Subject: AP1000 Responses to Requests for Additional Information (SRP 5)

AP1000 TECHNICAL REPORT REVIEW

RAI Response Number: RAI-SRP5.4.6-SRSB-01

Figure 1: Pressurizer Pressure

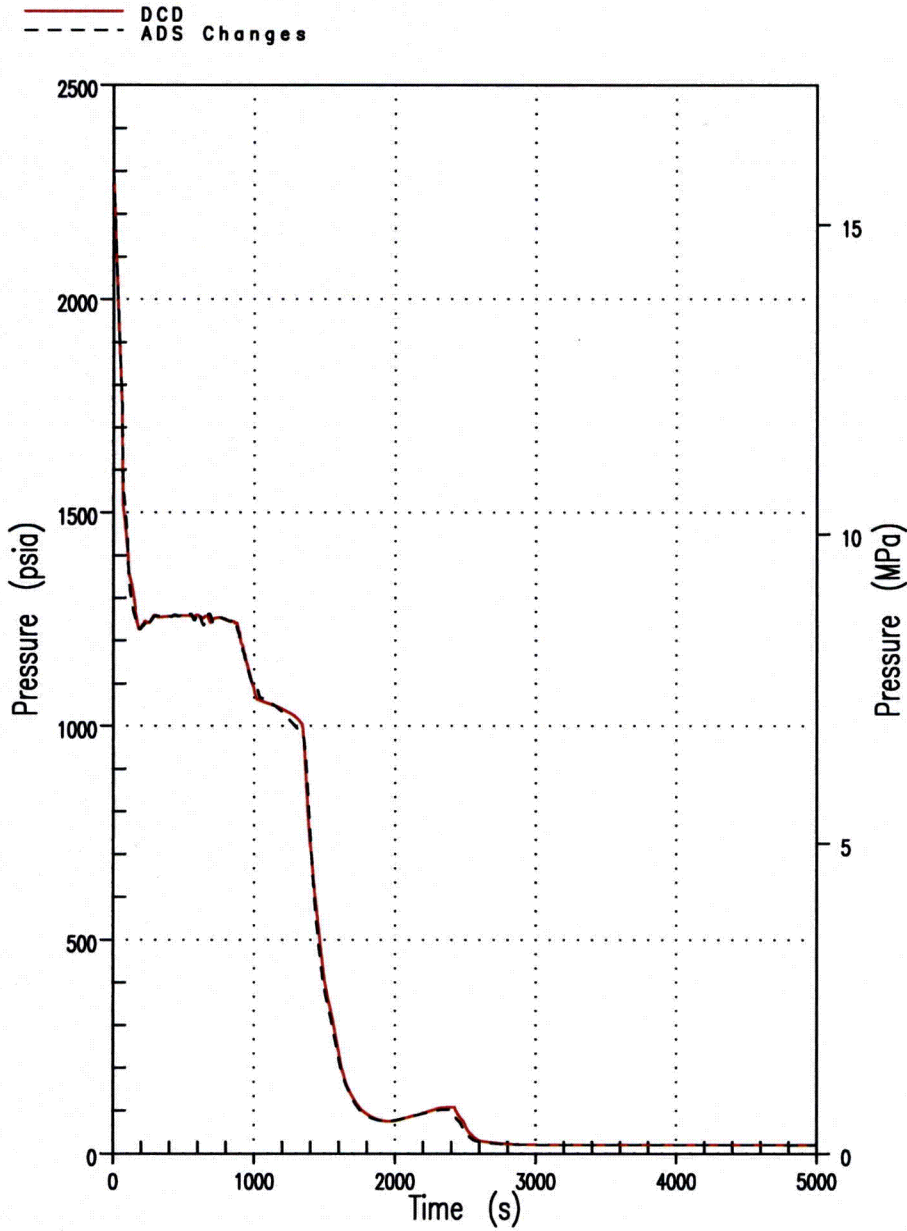
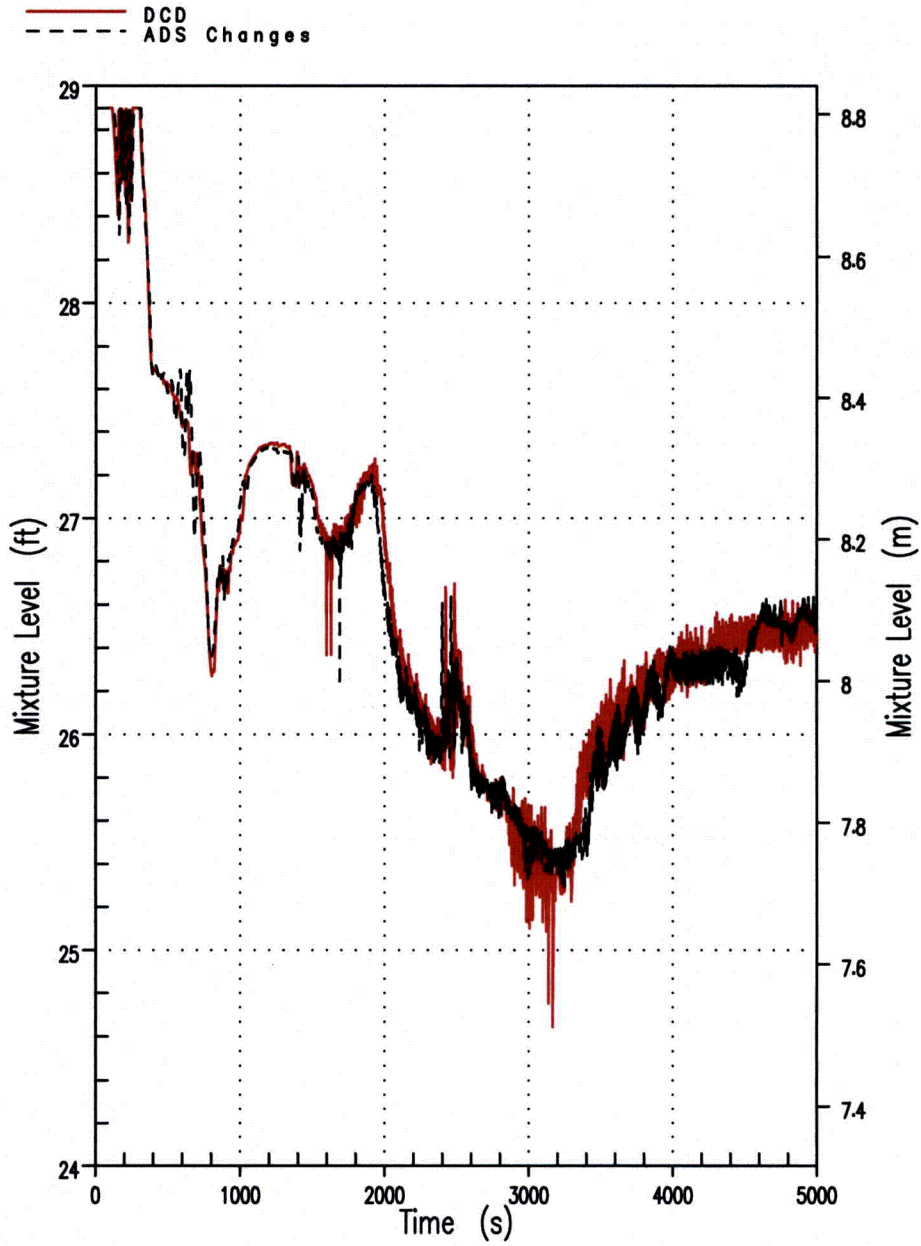
In Revision 17 to DCD, Tier 1 Table 2.1.2-4, Inspection, Tests, Analyses, and Acceptance Criteria (ITAAC), item 11.b, the acceptance criteria for the opening times (after receipt of signal from the PMS) of the remotely operated automatic depressurization system (ADS) stages 1, 2 and 3 valves (RCS-PL-V001A/B, V002A/B, V003A/B, V011A/B, V012A/B, and V013A/B) have been changed to longer times. Westinghouse AP1000 – DCD Revision 17 Changes Matrix indicates that the stroke times for these valves are modified to match actuator capacity.

Explain whether the changes of the ITAAC acceptance criteria of these ADS valve stroke times are consistent with the assumptions of the ADS valve opening time delay and stroke time assumed in the Chapter 15 safety analyses, and describe the effects of these changes on the safety analysis results of the events that result in the ADS actuation, such as small break loss-of-coolant accidents.

Figures 1 - 6 relate the comparison of the change in ADS valve (RCS-PL-V001A/B, V002A/B, V003A/B, V011A/B, V012A/B, and V013A/B) stroke times on the DCD 2" SBLOCA CL break transients. Figures 1 and 2 show minimal changes due to the change in stroke time. It is possible to discern a slightly higher pressure in the initial case at approximately 2400 seconds. This contributes to the slight differences observed in the integrated vapor and liquid flow resulting from time differences in the Stage 4 ADS actuation which is discussed below.
